# Kirklees Council

## Proof of Evidence of Adam Darwin FIHE

**Appeal reference:** APP/Z4718/W/25/3375000

**Site:** Land north east of, Shepley Road, Stocksmoor, Huddersfield, HD4 6XW

**Figure 1 – Location of (unrecorded) footpath entrances at Ch.540 & Ch.790 on Stone Wood Lane**

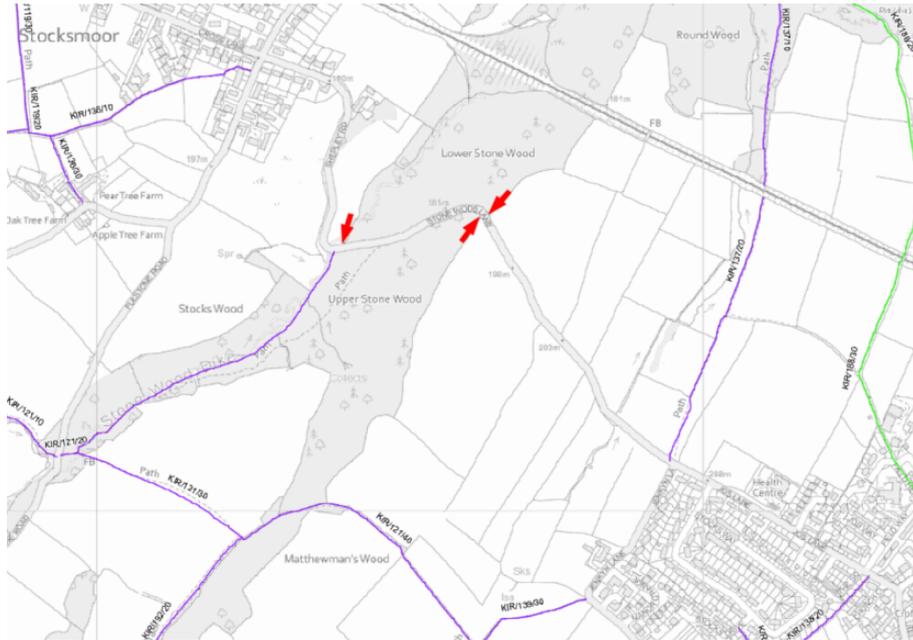
also includes a further access to the woods at and Ch. 790), which lead into Lower Stone Wood and Upper Stone Wood to the north and south of Stone Wood Lane respectively, which provide onward connections to the wider footpath network. Whilst these paths are not recorded on the Council's Definitive Map and Statement, they are well established and well used footpaths (based on my on-site observations), which have not been mentioned in the H&S SoC document or picked up in the survey data. Therefore, this omission also affects the reliability of the new survey data, and may explain why the active travel user flows at either end of Shepley Road & Stone Wood Lane do not match for the weekday survey (they can't match for the weekend survey as they were undertaken on different days), with some users taking circular walks through the wood that may not be picked up in the data.

- All of the surveys were undertaken in Autumn, when active travel users are unlikely to be at their peak (e.g. this would be more likely in summer months). Similarly, for the redone Saturday survey, this was undertaken during wet conditions, and it is clear from the data that this has suppressed the active travel user flow data. This is clear as the data undertaken at the Shepley Road end of the route, which the survey data sheets suggests was undertaken in dry conditions for both survey days, shows that the active travel users at the weekend (52 users over the 12hr survey) were substantially higher than the weekday data (31 users over the 12hr survey). However, for the data obtained on Stone Wood Lane to the southeast, which includes the redone weekend data obtained in wet conditions, this shows the complete opposite, with substantially fewer active travel users (8 users over the 12hr survey) for the weekend survey than for the weekday data (24 users of the 12hr survey). Therefore, the weekend survey data undertaken in wet conditions is not useful for assessment purposes.

3.31 In light of these issues, it is considered that the new Pedestrian / Cycle / Equine Survey data included in the H&S SoC document is unreliable, and limited weight can be given to the data. The data only provides a snapshot of active travel user activity, so also does not form a robust basis for assessment. That said, I note that the data for both the AM and PM weekday peak hour periods indicate lower active travel flows than for the hours on either side of these time periods, which provide some evidence (but of limited weight due to the deficiencies with the data, and it being only a snapshot of user activity) that active travel users are already avoiding Stone Wood Lane during the busier weekday AM and PM network peak traffic periods. For ease of reference, I have summarised the survey data for the hourly periods in **Appendix E**.

Figure 6.18 Private and commercial motor-vehicles – typical dimensions.

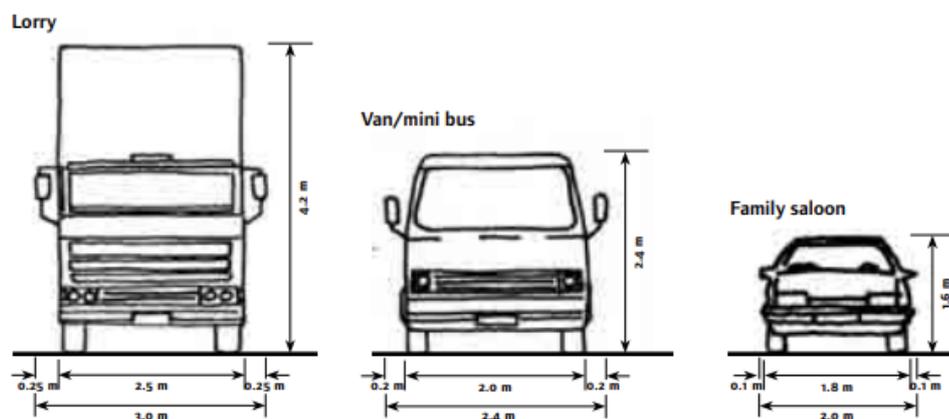
- 4.43 Due to the lack of footways along the entire route, the road operates as a shared surface highway. Based on the guidance contained in the Kirklees Highway Design Guide SPD [CD 6.6 – Table 1], a carriageway width of 5.5m is required for new shared surface roads, plus hard margins (0.6m wide) on both sides, to take account of vehicle overhang / edge shyness etc. This carriageway width allows 2m wide cars to pass, with a clearance of 0.5m between the cars and on each side of the carriageway (a similar 0.5m horizontal clearance is also recommended in ‘LTN 1/20 – Cycle Infrastructure Design’ [CD 7.18 – Table 5-3] for cycle clearances to vertical objects above 0.6m e.g. walls, fences and vegetation). The 5.5m carriageway width allows larger vehicles to pass, with a reduced level of clearance (e.g. based on two 2.4m wide vans passing, the available width between vehicles and each edge of carriageway would reduce to approximately 0.2m if it were split evenly), which is acceptable if traffic speeds are relatively low (e.g. a 15-20mph design speeds are identified in the Kirklees Highway Design Guide SPD, for both shared surface roads or higher order Type B streets of the same width). It is noted that the vehicle widths I have mentioned have been taken from Manual for Streets 1 (MfS1) [CD 7.3], as shown on Figure 6.18 extracted below. However, given that MfS was produced in 2007, and private car widths have increased since this time, the clearance widths I have identified will now be lower.

- 4.44 Based on the above, the majority of Stone Wood Lane along the two-way sections (including passing places) is of insufficient width (e.g. below 5.5m) to allow two light vehicles to pass comfortably, even at the low speeds (e.g. below 20mph). Therefore, I do not accept the assertion that traffic speeds on Stone Wood Lane are low, as suggested by the Appellant, with the recorded 85<sup>th</sup> percentile speeds along the entire route being consistently above a suitable speed (e.g. 20mph) for this width of shared surface road, with the occasional driver travelling well in excess of this (e.g. a speed of 50-55mph has been recorded for a driver travelling down the hill through the single-track section through Stone Wood close to PP-J).

Figure 7.1 Illustrates what various carriageway widths can accommodate. They are not necessarily recommendations.

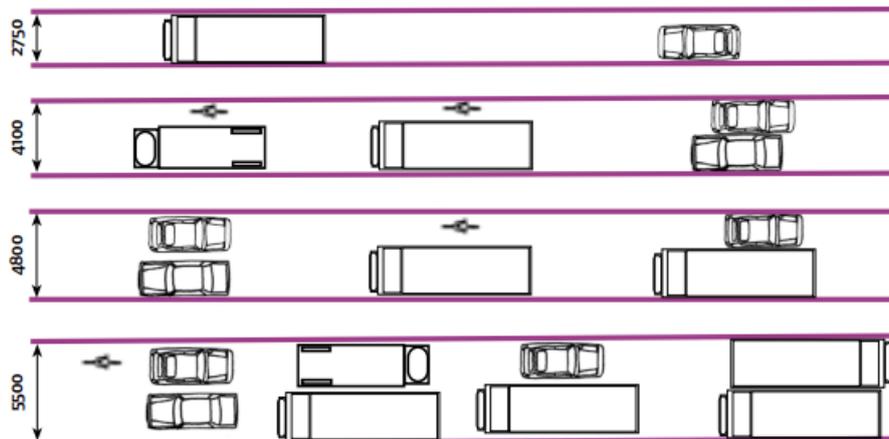
- 4.45 The Appellant has suggested that a 4.8m carriageway width is adequate to allow a car to pass a van, and a 4.1m width is sufficient for two cars to pass. They have based this assumption on the dimensions shown on Figure 7.1 of MfS1[CD 7.3], which is extracted below:

- 4.46 I accept that a 4.8m wide carriageway can allow a car and van to pass at low speed (e.g. less than 20mph), but the level of clearances I have previously identified would be significantly reduced (e.g. based on a 2.4m wide van, passing a 2m wide car, the available width between the passing vehicles and each edge of carriageway would be approximately 0.15m if split evenly). Therefore, this narrower width would involve closer passing of vehicles, increasing the risk of collisions between passing traffic (e.g. clashing wing mirrors etc.). This also doesn't take account of the edge treatment at the side road, which requires additional clearances (e.g. a safe distance would be 0.5m to a boundary wall, fence or other vertical obstruction, as previously mentioned).

- 4.47 However, I do not accept that a 4.1m carriageway width is adequate to allow two cars to safely pass, as this would only provide 33mm clearance (if evenly split 3 ways) between vehicles and each edge of carriageway, which is clearly inadequate at any speed. It is also noted that Figure 7.1 from MfS [CD 7.3] states that the identified widths are not recommendations. Whilst I acknowledge that smaller cars may be able to physically pass at this narrow 4.1m carriageway width (and this does occur on Stone Wood Lane at the very narrowest of the passing places that exist), this is not a safe or comfortable width for vehicles to pass, and is likely to result in low speed collisions with passing traffic or adjacent boundary features (an issue I have experienced myself when using the route, where I have scraped my vehicle on vegetation when passing at one of the very narrow informal passing places / PP-F).

**Figure 2 – Middle Super Output Area (MSOA) 051 & 056**

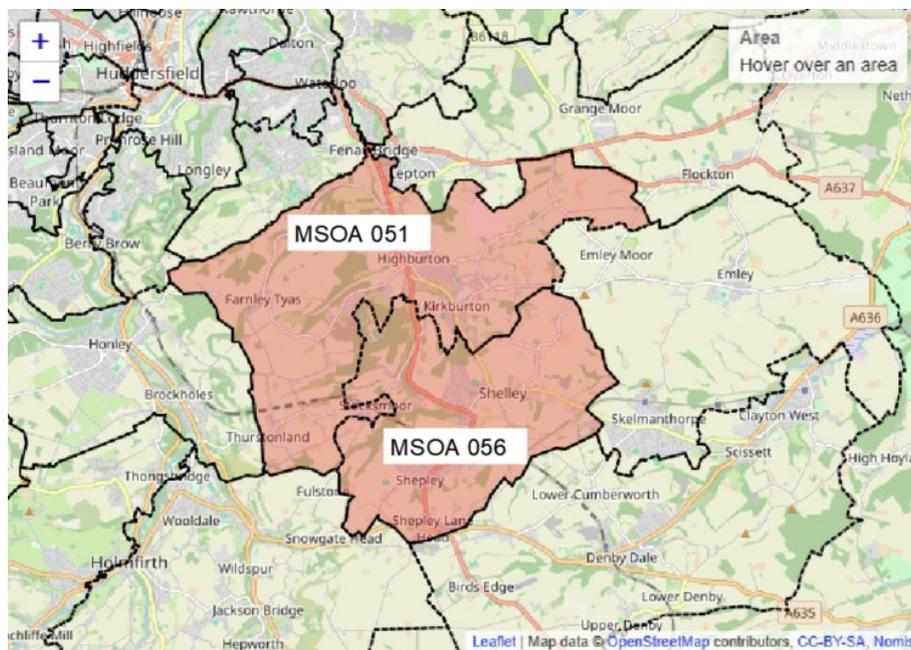
- 5.34 Data from TEMPro for Middle Super Output Areas (MSOA) 051 & 056 (See MSOAs on Figure 2 below) has been used to determine vehicle journey purpose for car trips (rather than assessing all mode trip types, which is a better approach) at the Appeal site. This data has been used as Stocksmoor lies on the edge of these two MSOA, which the LPA does not dispute. However, using this data from a wide area, and then applying it to the Appeal site is incorrect, as this assumes that the travel patterns and modal split of people living in Stocksmoor are the same as people living in the remaining areas of MSOA 051 & 056. It is noted this wider area includes the villages of Shepley, Shelley, Kirkburton and Highburton, which all have a range of local facilities, including schools (both primary and secondary), shops, medical facilities etc. that are within easy walking distance. This is not the case for the Appeal site, which is not within easy walking distance of any such facilities, and the most direct walking route to the nearest facilities that accommodate the daily needs of residents is along Stone Wood Lane when walking to Shepley (a walk of over 1km before reaching any local facility). In particular, the data relating to primary education trips will certainly not be the same for the Appeal site as in the wider MSOAs, as it will be easy to walk to a primary schools for a large proportion of people living in the other villages, which will clearly not be the same for the Appeal site, where it is likely that the vast majority of all trips to/from primary school will be by car (or by bike, should parents feel safe to do so). Unfortunately, the TEMPro database cannot be focused in sufficiently to consider only Stocksmoor and surrounding rural areas that are less accessible, to allow more localised journey purpose information to be considered. Had this been the case, using the smaller Lower Super Output Area scale census data (e.g. If it

- 5.35 The Appellants H&T SoC document [CD 8.2] has assigned commuter trips using 2011 Census data for MSOA 051 & 056. Whilst it has not been confirmed in the report, it is understood that this has been done using the '*WU03EW - Location of usual residence and place of work by method of travel to work (MSOA level)*' dataset, utilising the car/van driver data. This assessment approach is relatively standard and has been used for many years, and can provide an indication of commuter traffic distribution (and is often used as a proxy for the modal split for all journey types). However, the 2011 Census data is now old and does not reflect current commuter patterns. Unfortunately, the later 2021 Census data cannot readily be used for the same purpose, as it was affected by Covid restrictions, so there is no more recent Census data that could be used. Therefore, the usefulness of the 2011 Census data is diminishing, as the data is outdated and unreliable. This is one of the reasons why the LPA had asked for a 'first principles' type assessment of trips by all modes and trips types for the assessment, and accords with the principles in the NPPF that require a Vision-led approach to assessment and not 'predict and provide' as has been done consistently by the Appellant's various transport consultants in their assessments.

**Figure 3 – Lower Super Output Area (LSOA) 051D**

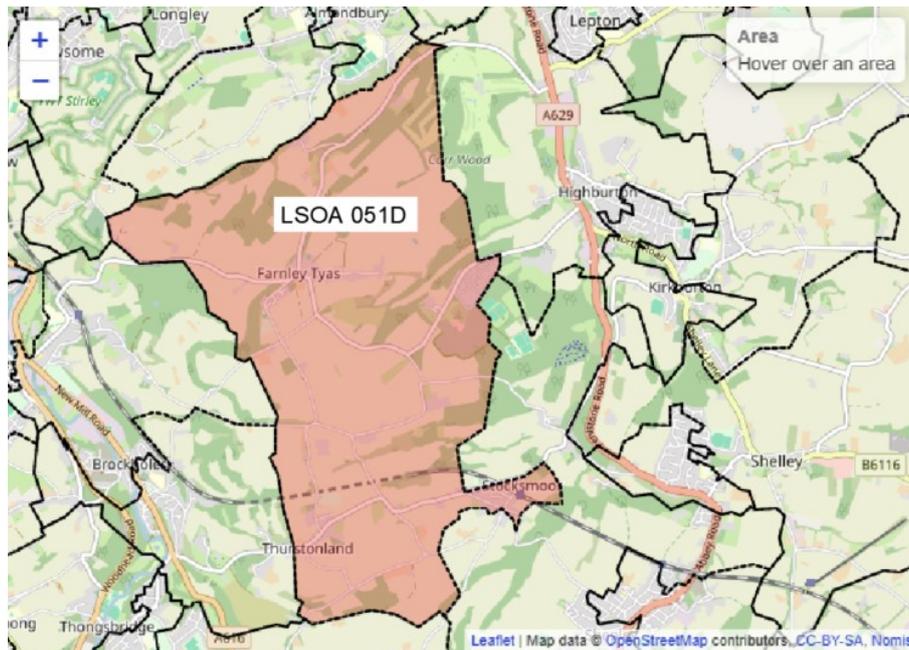
had been possible to use LSOA 051B – see area on Figure 3 below), could have provided more representative data for trip distribution purposes (and using the data for all trip types). However, TEMPro can only consider the larger MSOA datasets, which in this case incorporate villages with very different travel characteristics to Stocksmoor. As such, the journey purpose data for car trips used by the Appellant are unreliable, and provide a flawed assessment approach, ignoring that during peak hour periods, more people will be travelling by car for other purposes (e.g. taking children to primary school) who live in Stocksmoor. A better approach would have been to determine journey purpose for all trip types during network peak periods, and then applying a reasoned and justifiable modal split to each trip type (e.g. 100% of primary school trips by car).
